Compliance Dams

401 “Baseline”

Perimeter
Containment
Areas (PCAs)
reduce flows

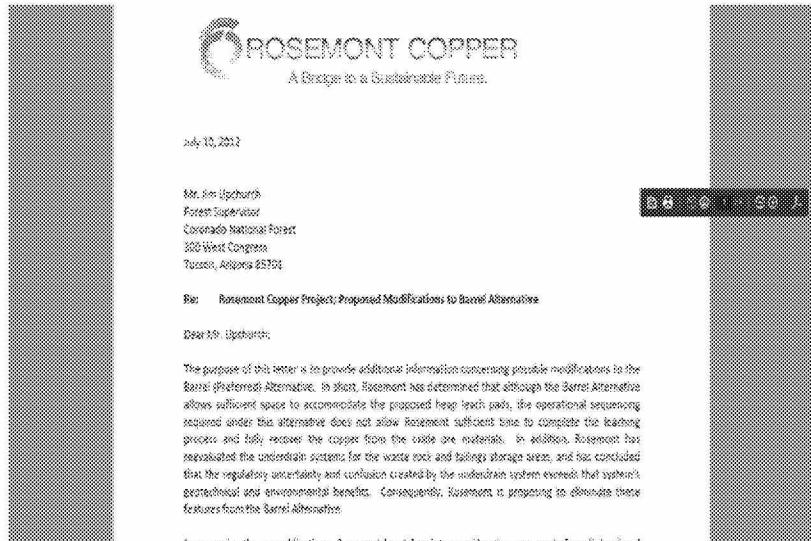
- Perimeter containments could be drained to reduce impacts.
- No analysis of impacts of retaining this runoff.

- Unnecessary reduction of flows to Barrel and Davidson
- Increased contact and potential for water quality impacts
